Request: BUILDING PERMIT

Address: 10542 Murdock Dr.

**5-C-22-TOB
CERTIFICATE OF APPROPRIATENESS**

A NEW BUILDING FOR
HARPER COLLISION
 MURDOCK DRIVE
 KNOX COUNTY, TN
 TTCDA FILE # 5-C-22-TOB PC # 5-E-22-UR

Concept Site Plan

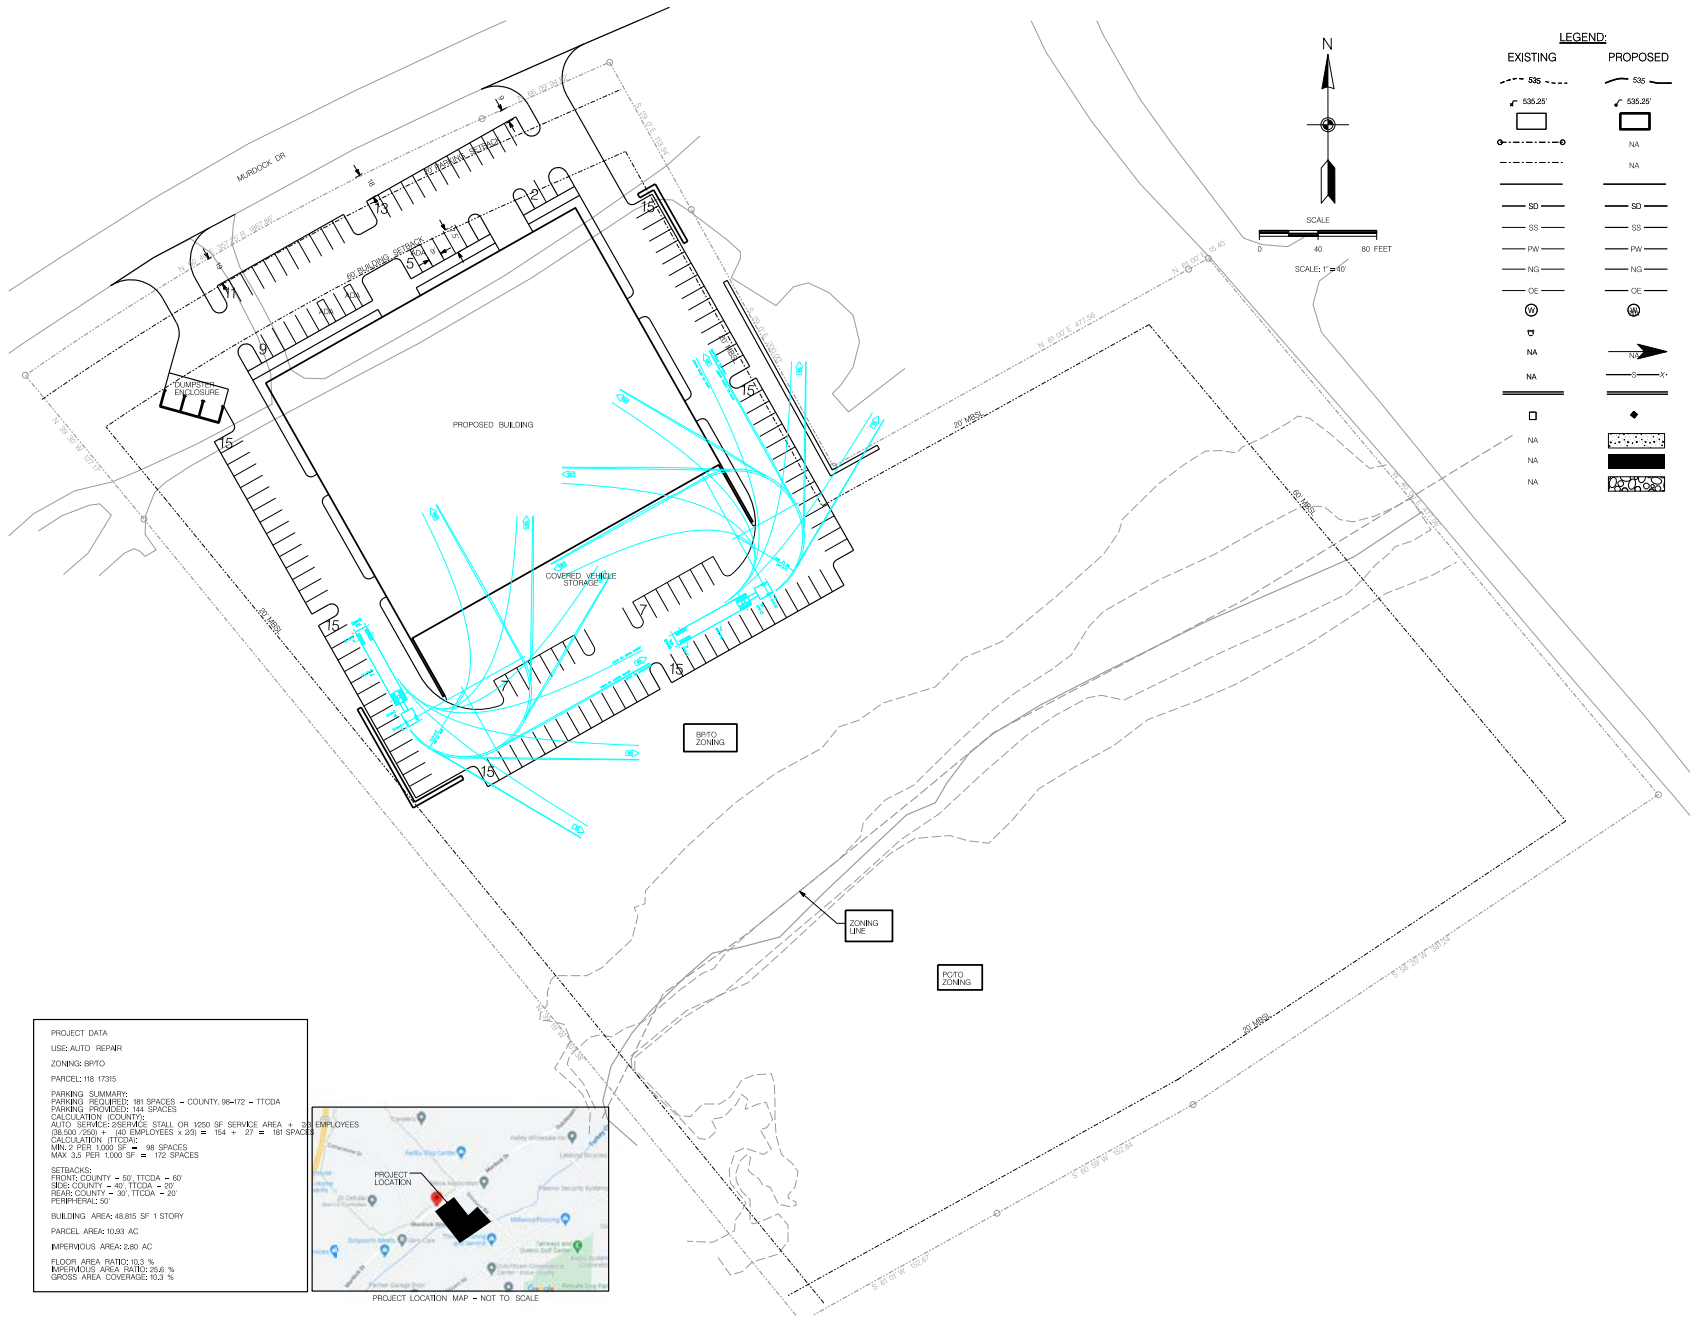
- 3) The site is somewhat constrained with a stream running through the rear of the site and a stream protection area designated over part of the property. A 50-ft buffer is required on either side of the stream. Site development occurs to the north of the stream and leaves the stream area largely intact with no grading to occur within the stream buffer area or south of that.

- 4) The site is bounded by small retaining walls. A short wall approximately 18 inches tall is on the front eastern end of the parking area, and another wall ranging from 18 inches to 6.5 ft is located just below that on the plans. Another wall ranging from 1 to 11 ft in height is located at the southwest corner of the parking lot towards the rear of the site. Since the site is not in a Hillside Protection area, there are no restrictions or design guidelines pertaining to the retaining walls.

- 5) There are two access points proposed off of Murdock Drive, a minor arterial. Parking is located to the front, side, and rear of the building. A 20-ft parking lot setback is required when parking is located in front of a building. The applicant is requesting a waiver to reduce this requirement to 8 ft on the eastern edge of the parking lot and 19 ft on the western edge. Staff supports this waiver due to the site constraints to keep the development further from the

9) Parking is proposed to the side and rear of the building. The front parking is screened from the street by landscaping, and the side parking is screened by the fencing.

10) TTCDA would require between 98 and 142 spaces, and the County Zoning Ordinance would require a minimum of 181 spaces with no maximum. Plans propose 144 spaces, and a waiver is required to increase the TTCDA parking requirement by two spaces. Since the increase is minimal and the parking is screened from the street, staff supports this waiver.

- 1) Approve the waiver to reduce the parking lot setback to 8 and 18 ft as requested due to topographic conditions on the site.
- 2) Approve the waiver to increase the number of allowed parking spaces to 144.

1 FIRST FLOOR PLAN

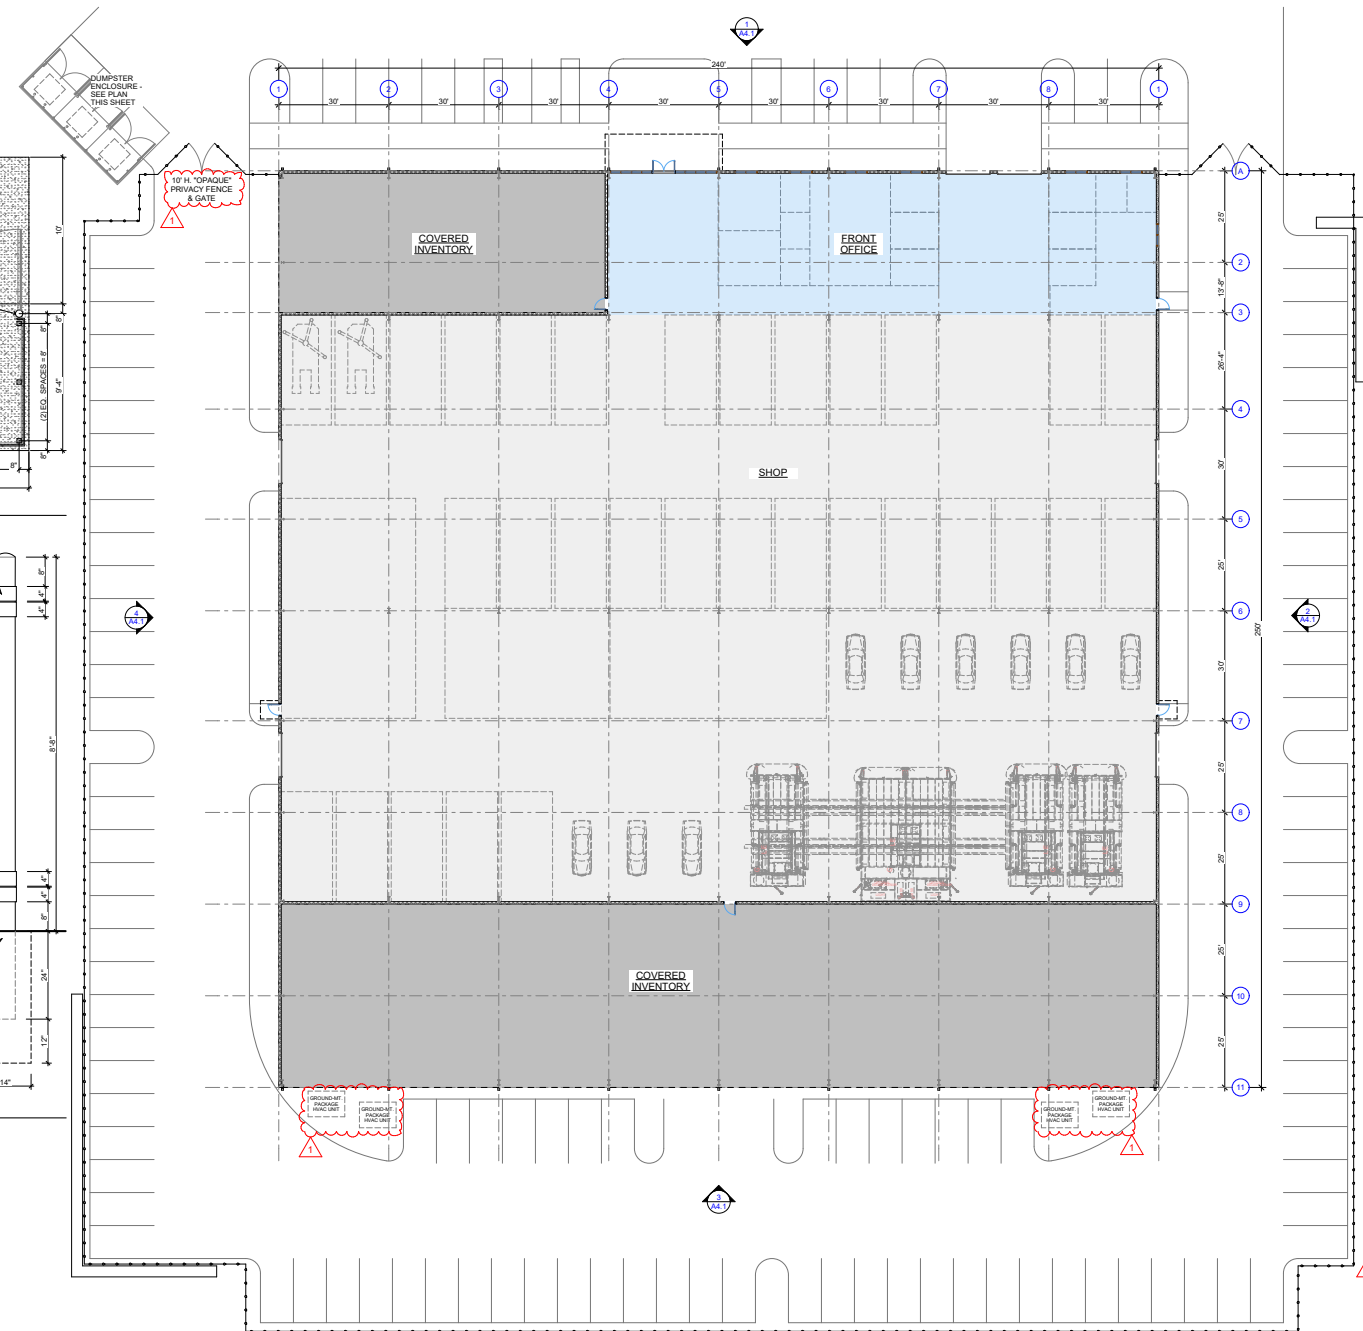
7) There are six roll-up garage doors on the building, with two each located on the front and side facades. The garage doors feature glass panes with dark mullions, which take on more of a storefront window quality when closed.

SITE PLAN - ILLUMINATION

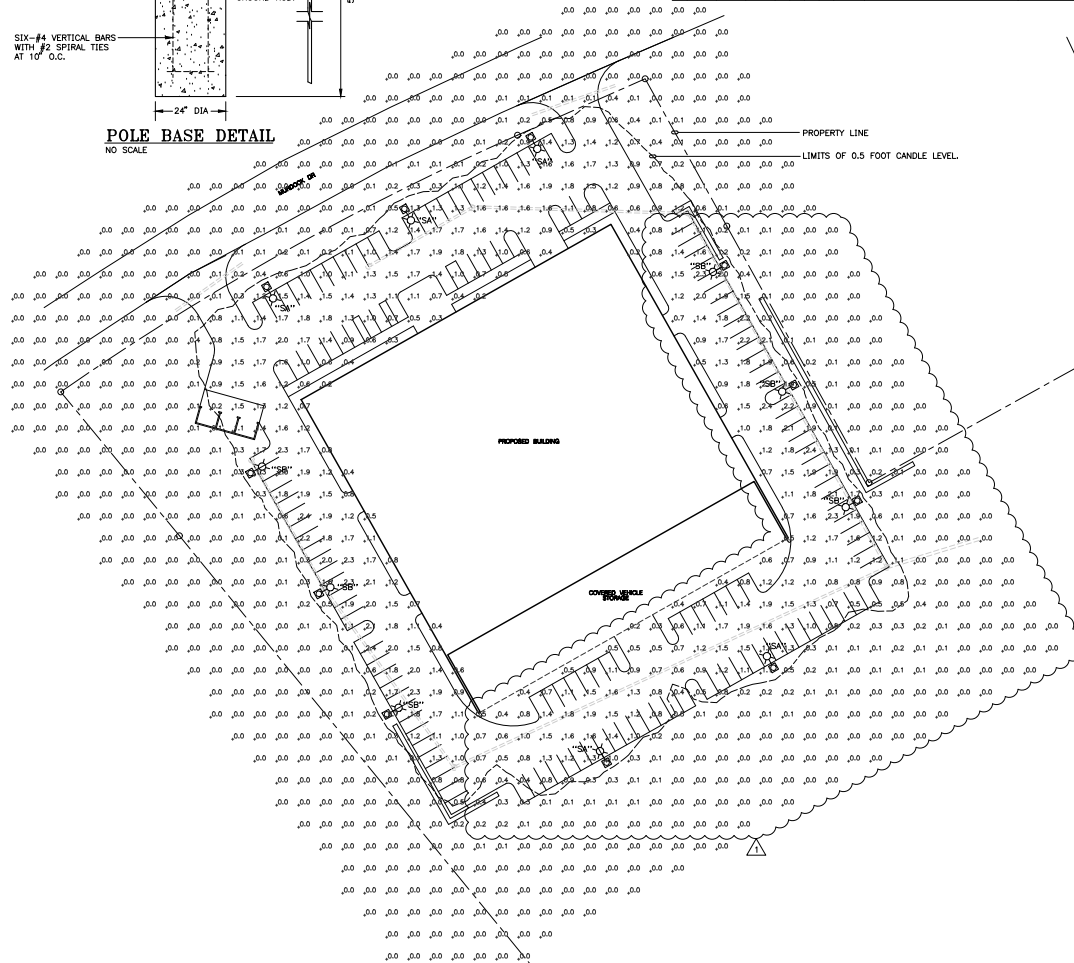
13) The proposed lighting includes 11 light poles along the perimeter of the parking areas for safety and security. Proposed light fixtures are full cut-off, utilize LED lighting, and meet the TTCDA Guidelines. Lighting levels likewise meet the TTCDA Guidelines.
